Addendum 12H – Regulation 13-H

Revision 1 – Amendment 4

Supplement 9 to the original version of Regulation: Date of entry into force: 17 March 2010

UNIFORM PROVISIONS CONCERNING THE APPROVAL OF PASSENGER CARS WITH REGARD TO BRAKING

Figure 1a: Pedal force characteristic needed in order to achieve maximum deceleration with category "A" BAS

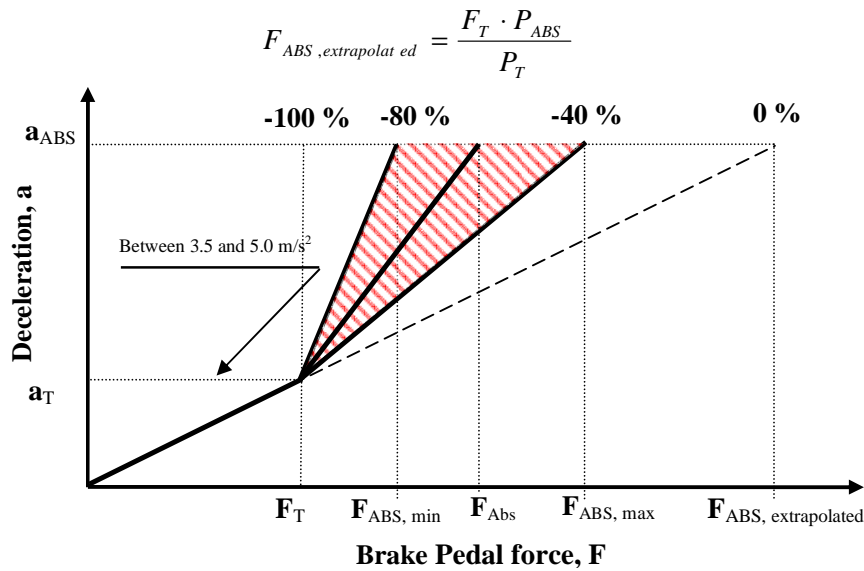
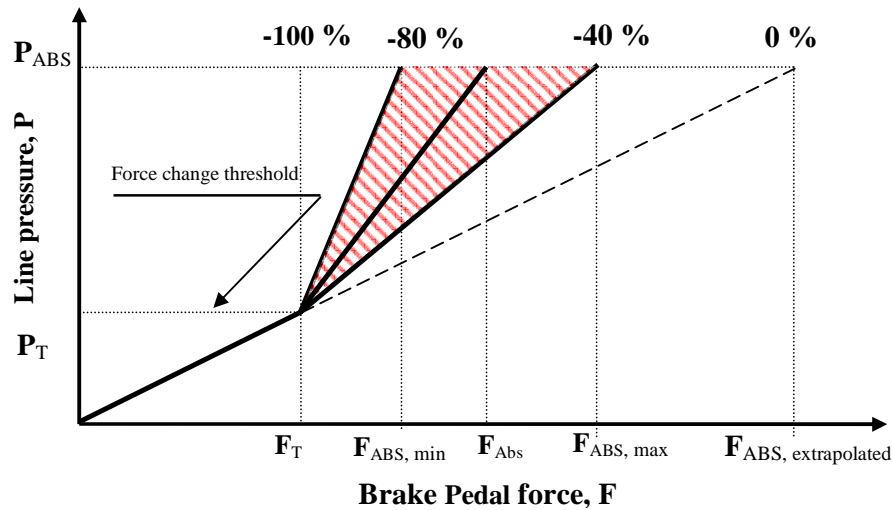
3.2.3. F_T and a_T are threshold force and threshold deceleration as shown in Figure 1. The values of F_T and a_T shall be supplied to the Technical Service at the time of submission of the type-approval application. The value of a_T shall be between 3.5 m/s² and 5.0 m/s².

3.2.4. A straight line is drawn from the origin through the point F_T, a_T (as shown in Figure 1a). The value of brake pedal force "F", at the point of intersection between this line and a horizontal line defined by $a=a_{ABS}$, is defined as $F_{ABS, extrapolated}$:

3.2.5. As an alternative, which can be selected by the manufacturer, in the case of vehicles of category N_1 , or M_1 derived from those N_1 vehicles, with a gross vehicle mass $GVM > 2,500$ kg, the pedal force figures for $F_T, F_{ABS, min}, F_{ABS, max}$ and $F_{AB, extrapolated}$ may be derived from the brake line pressure response characteristic instead of the vehicle deceleration characteristic. This shall be measured as the brake pedal force is increasing.

The presence of a category "A" BAS is proven if

$$F_{ABS, min} \leq F_{ABS} \leq F_{ABS, max}$$

$$F_{ABS, max} - F_T \leq (F_{ABS, extrapolated} - F_T) \cdot 0.6$$

$$F_{ABS, min} - F_T \geq (F_{ABS, extrapolated} - F_T) \cdot 0.2$$

Figure 2: Example of test 2 of a category "B" BAS system

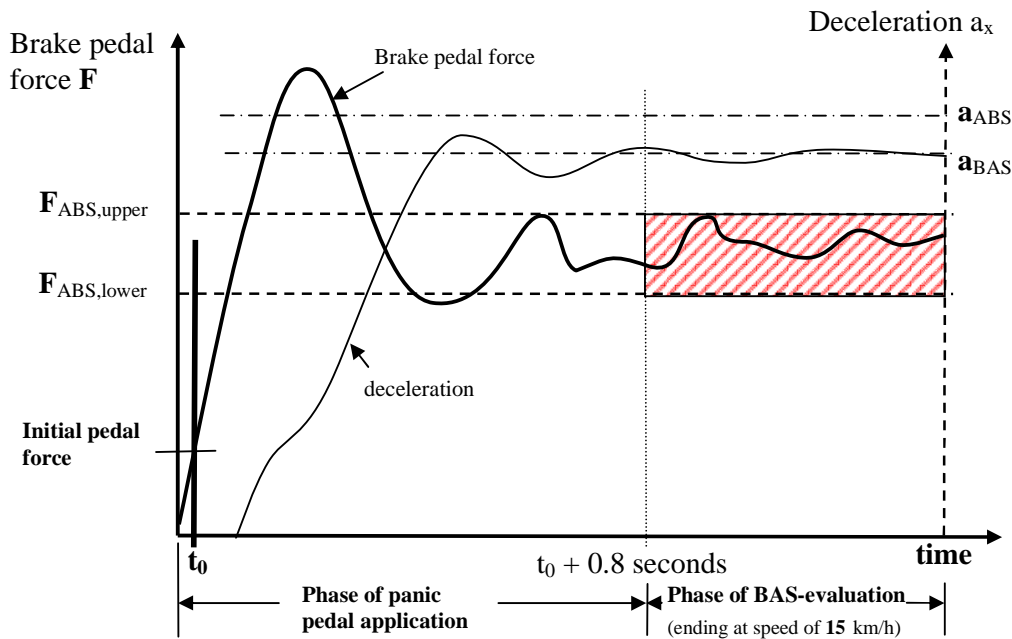
The vehicle shall be driven in a straight line at the test speed specified in paragraph 2.4. of this section. The driver shall apply the brake pedal quickly according to Figure 2, simulating emergency braking so that BAS is activated and ABS is fully cycling.

After $t = t_0 + 0.8$ s and until the vehicle has slowed down to a speed of 15 km/h, the brake pedal force shall be maintained in a corridor between $F_{ABS, upper}$ and $F_{ABS, lower}$, where $F_{ABS, upper}$ is $0.7 F_{ABS}$ and $F_{ABS, lower}$ is $0.5 F_{ABS}$.

The presence of BAS 'B' is demonstrated if a mean deceleration (a_{BAS}) of at least $0.85 \cdot a_{ABS}$ is maintained from the time when $t = t_0 + 0.8$ s to the time when the vehicle speed has been reduced to 15 km/h.

Figure 3: Deceleration corridor for determination of F_{ABS} and a_{ABS}

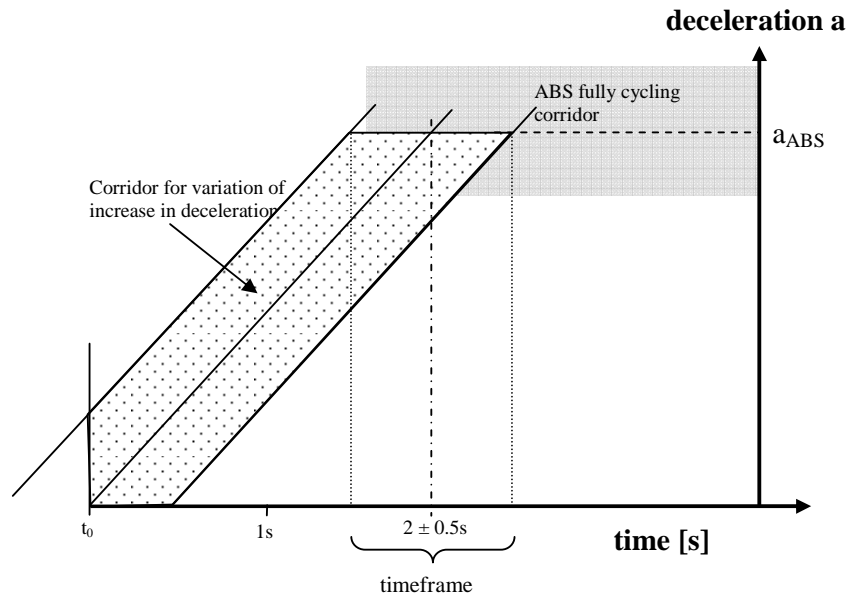
- 1.2. The brake pedal shall be applied slowly (without activating the BAS in the case of category B or category C systems) providing a constant increase of deceleration until ABS is fully cycling (Figure 3).

- 1.3. The full deceleration must be reached within the timeframe of 2.0 ± 0.5 s. The deceleration curve, recorded against time, must be within a corridor of ± 0.5 s around the centre line of the deceleration curve corridor. The example in Figure 3 has its origin at the time t_0 crossing the a_{ABS} line at 2 seconds. Once full deceleration has been achieved the pedal travel S_p shall not be decreased for at least 1 s. The time of full activation of the ABS system is defined as the time when pedal force F_{ABS} is achieved. The measurement shall be within the corridor for variation of increase in deceleration (see Figure 3).
